Comment 1

Section 2 5 3. The last sentence, first paragraph, regarding Segment 5, is incorrect and the classification of Segment 4 should be added. Acceptable replacement text is: Classifications of Segment 4 and Segment 5 are aquatic life, warm water (Class 2), water supply, agricultural and recreational Class 2.

ENVIRONMENTAL MANAGEMENT WORKPLAN

Figure 4 4-2 Approximate Schedule for Evaluation of Promulgated Technologies

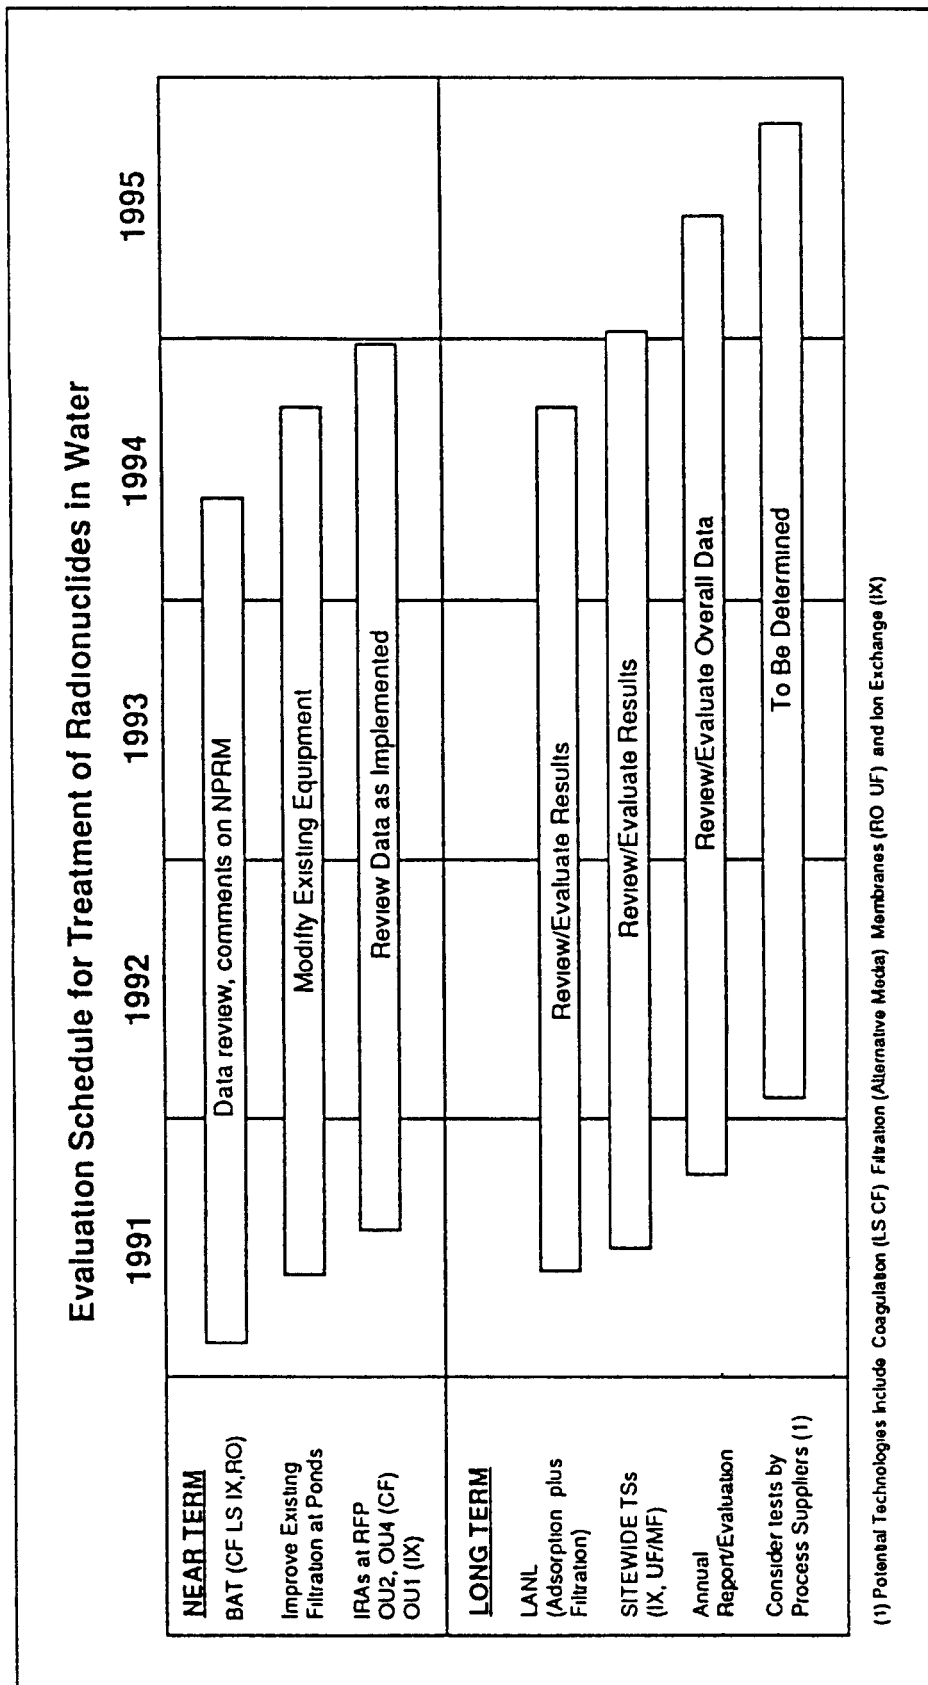
Section 4 4 3 7. The Division welcomes the annual reviews of potentially applicable treatment technologies Additionally, the Division would like the annual review to include an updated and revised schedule comparable to Figure 4 4-2 Likewise, the Division would like annual updates on the progress of improvements to DOE analytical capabilities, schedules for any additional work should be included

An update to this Workplan will be a followup report that summarizes the advances in technology and evaluates these advances for potential applicability to RFP based on the need to control radionuclide discharges by application of treatment technology Plans for additional work will be included, as appropriate This followup report will be included as part of the Sitewide Treatability Study Plan (TSP) annual report
